HAYWARD WEST SUBDIVISION

EASTERN CONNECTICUT ENVIRONMENTAL REVIEW TEAM REPORT

REVIEW DATE: OCTOBER 4, 1988

Hayward West Subdivision Colchester, Connecticut

**SCHEMATIC SUBDIVISION PLAN**

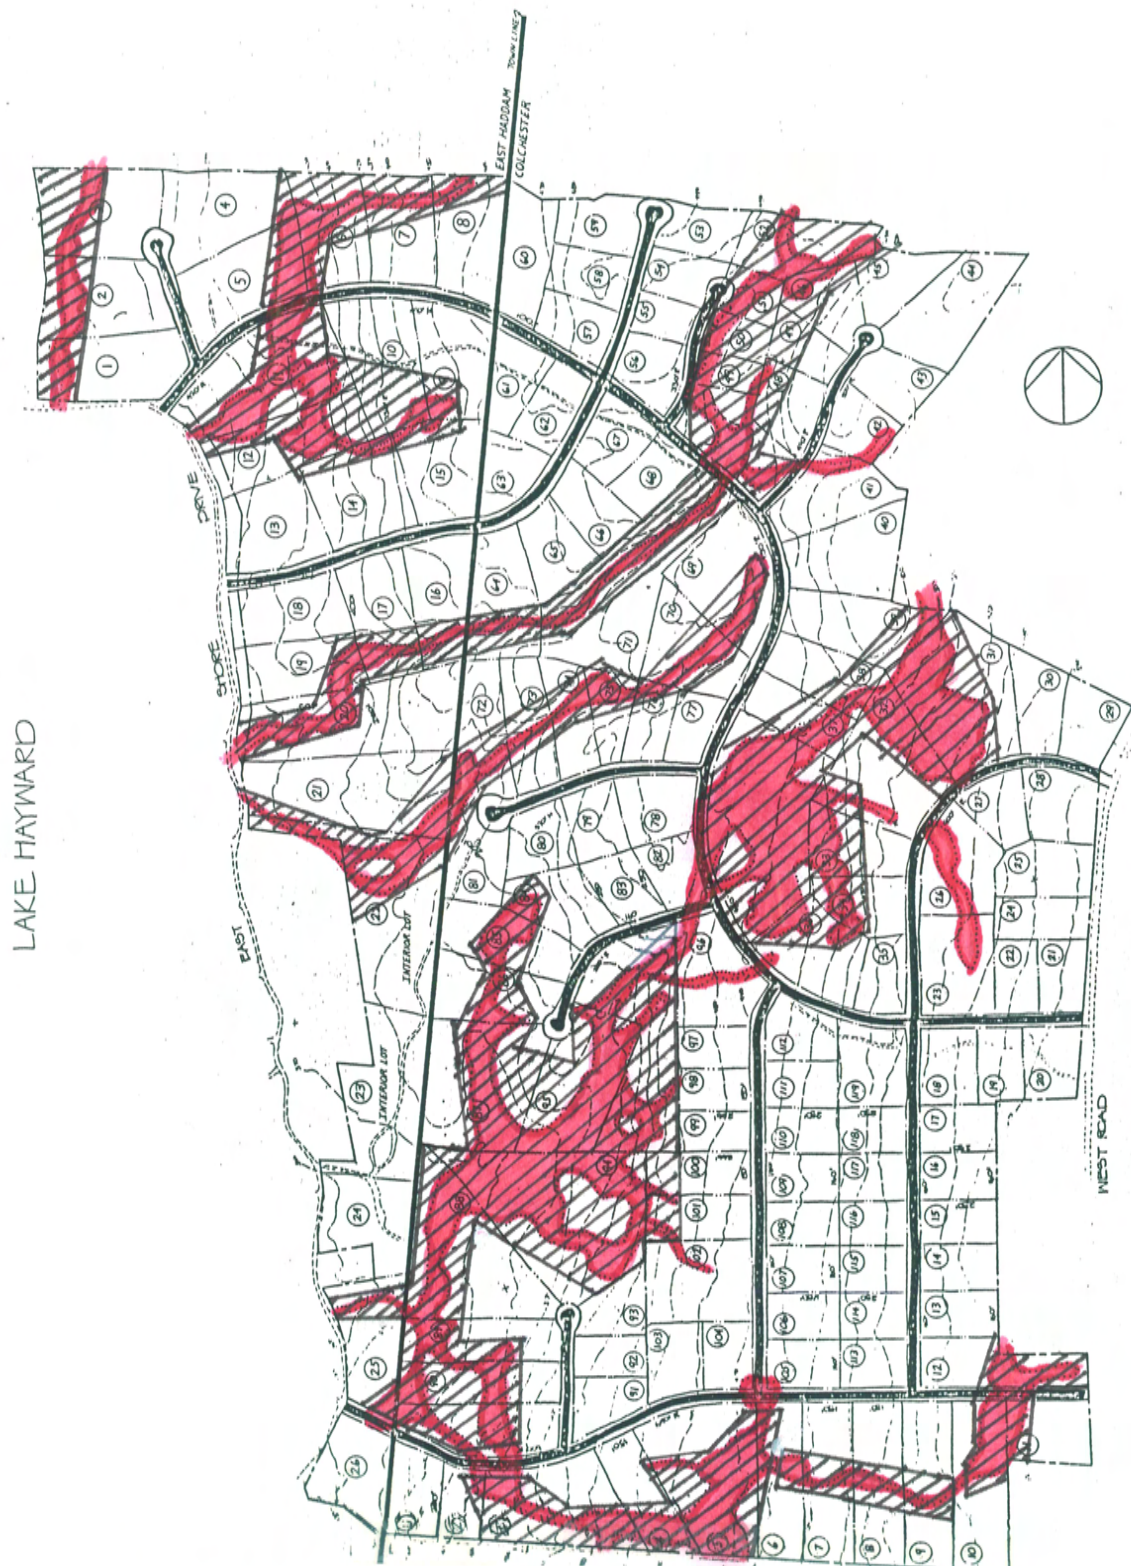
NOTE: This section of the report will refer to lot numbers as presented on the "Schematic Subdivision Plan" revised to reflect the elimination of the road which ran between and parallel to Oak Terrace and Cedar Place.

1. There are thirteen (13) proposed wetland crossings for road access:

- a. between lots 11 and 12
- b. between lots 104, 105 and 5, 6
- c. between lots 90A and 2, 3
- d. lot 25 (East Haddam)
- e. lot 26
- f. lots 31, 32
- g. between lots 36 and 96
- h. between lots 36A and 78, 82
- i. between lots 82 and 96
- j. between lots 51A and 71
- k. between lots 51A, 51 and 41, 42
- l. between lots 5, 6 and 11 (East Haddam)
- m. lot 47
- n. minimally, road grading will affect the wetlands on lots 69, 72, 81, 95, 86, 87, and 90A

2. Seven (7) lots would require driveway crossings of the wetlands to access buildable land, specifically: lots 6, 10, 26, 70, 71, 72 in Colchester; and lot 22 in East Haddam.

3. There would be significant adverse impacts on the wetlands in at least twenty (20) lots during and after development through site preparation, filling, grading and other incidental intrusions. Specifically on: lots 3, 5, 26, 31, 42, 47, 50, 51, 70, 71, 85, 86, 87, 90, 94, 95 and 96 in Colchester; and lots 6, 11, and 22 in East Haddam.

1. Reconfigure the roads to minimize the number of road crossings.

a. Is access from the main road at this point necessary? The road is a through road from West Road to East Shore Drive. If this access is not necessary, from a wetlands standpoint, it would be better to eliminate this access point and put a cul de sac at the east end of Deerfield Crossing to serve lot 10.

b. Although the wetlands could be bisected at a narrower point, the wetlands under the proposed intersection of Woodbridge road and Deerfield Crossing are marginal, whereas the wetlands to the south, the narrow point of the wetlands and the wetland area this broadens into, would be better served by maintaining the road crossing at the edge of the wetlands where currently proposed. The other alternative to this would be to reconfigure the road keeping it entirely out of this wetland area.

c. If access across this wetland area is needed to connect Deerfield Crossing to East Shore Drive grading should be kept to a minimum, and culverts should be placed under the road to preserve the hydraulics in both portions of the wetlands.

d. Move the road to the south to eliminate impact on the wetland in this location.

e., f. and m. Realign the roads to avoid impacts on the wetlands.

g. and h. The course that Forest Street follows should be revised to significantly reduce the wetland impacts. One way this could be accomplished would be to move the road 75 feet to the west. This would allow the road to cross the stream perpendicularly, rather than eliminating a large portion of the stream and associated wetland by following the stream bed.

i. The elimination of either Viti Court or Ashford Place would potentially result in a more sound servicing of the area by road and a better configuration of lots with less impact on the wetlands.

k. A reconfiguration of Forest Street would eliminate the need to cross the wetlands with Ashford Place.

l. As currently proposed, Forest Street crosses the wetlands at this location in one of the widest points possible. The crossing should be moved to the south where there is already an impacted area of an old road crossing or a report from a biologist should be submitted by the applicant explaining why there would be less impact to the wetlands by crossing at the widest point.

POSSIBLE GREENBELT ZONES

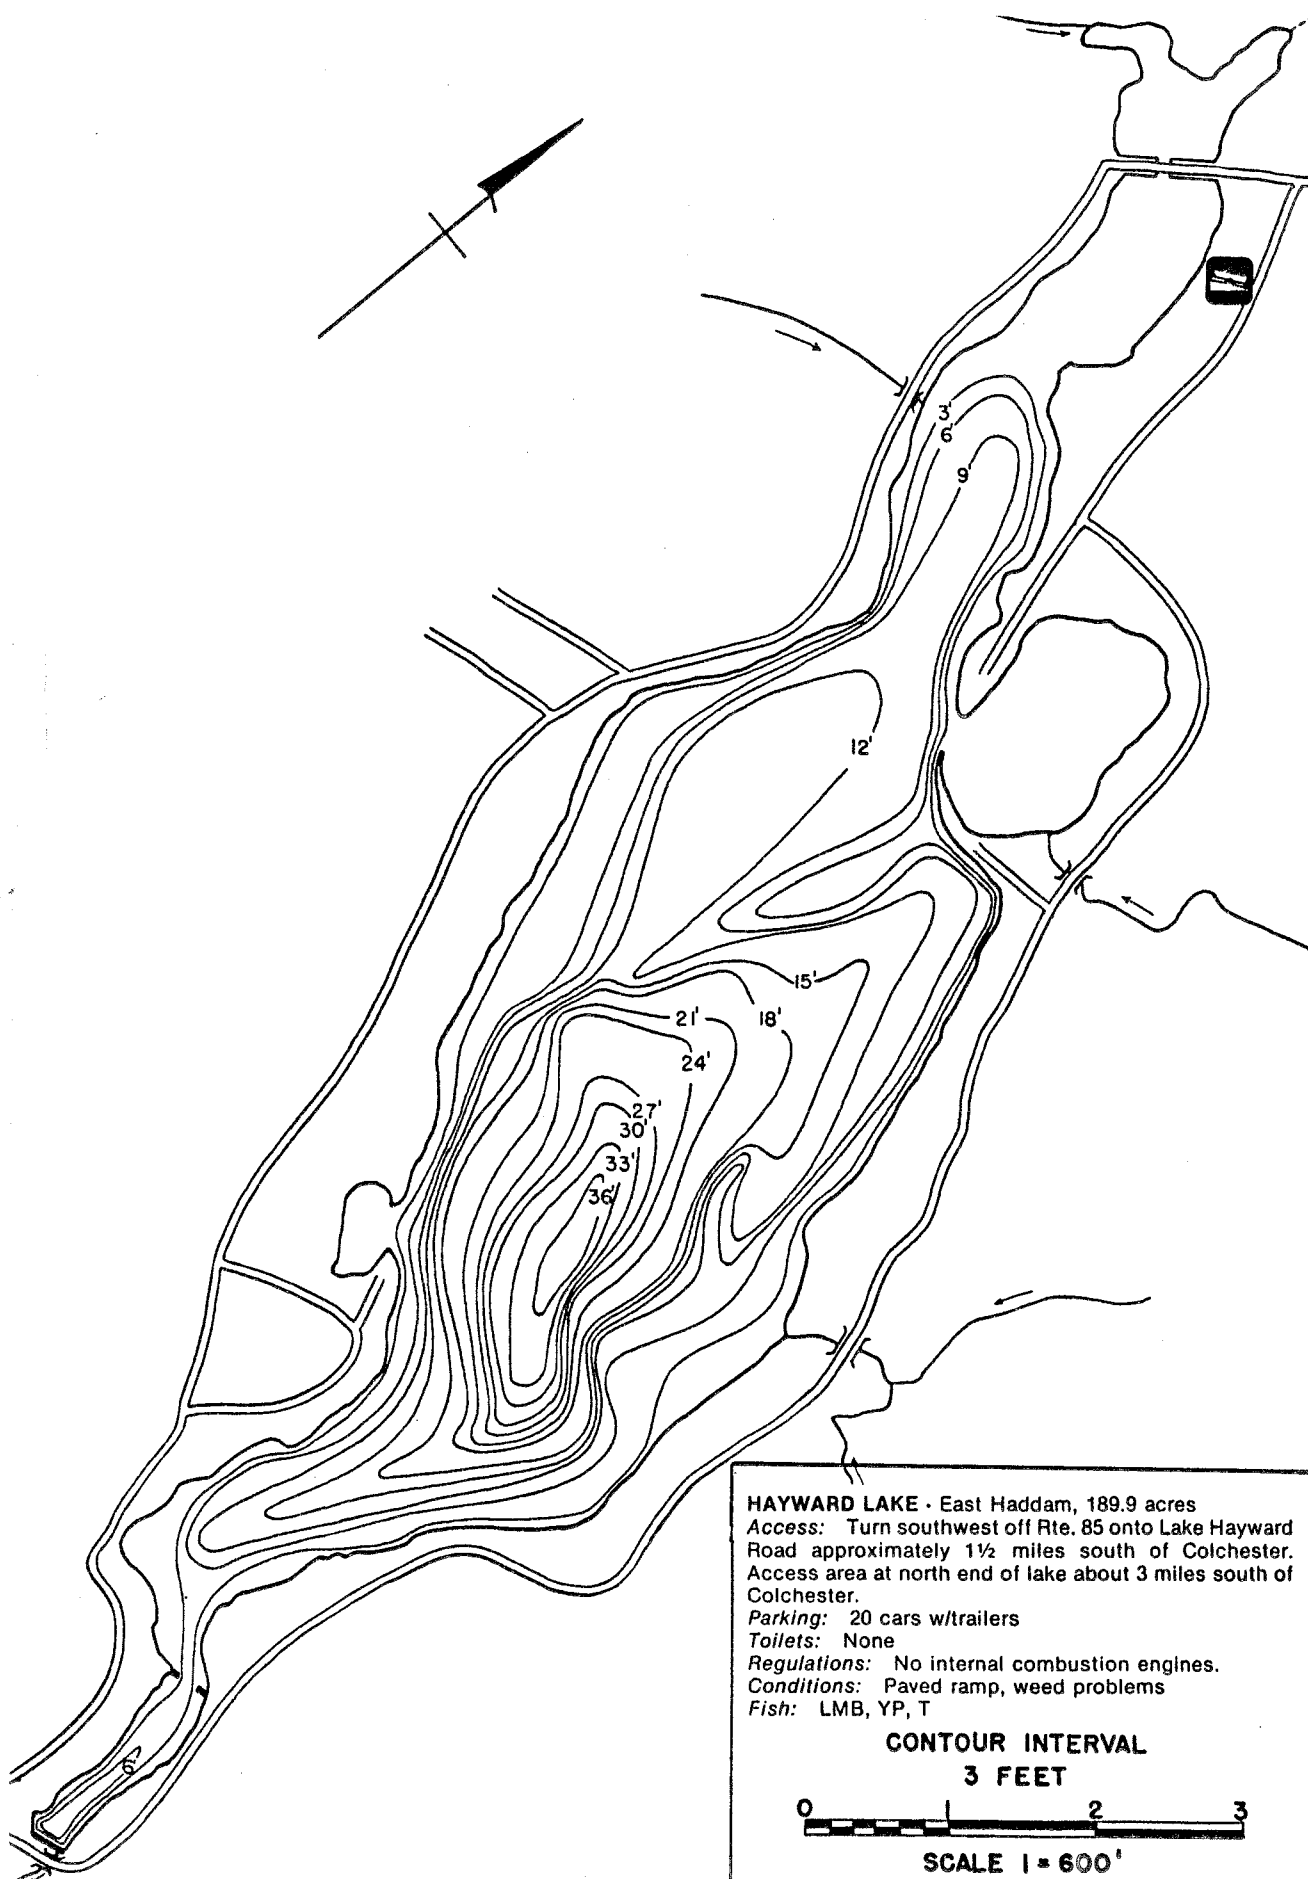
In summary, this site has significant resource restrictions. The wetlands on the property function in preserving the water quality of Lake Hayward as well as a wildlife refuge. The road should be realigned to coincide with the resource restrictions. To best protect the wetlands and future public health, safety and welfare "green belts" should be established around the wetland/watercourse corridors and this land be dedicated as open space and/or have conservation easements imposed on the sensitive areas. (see attached diagram)
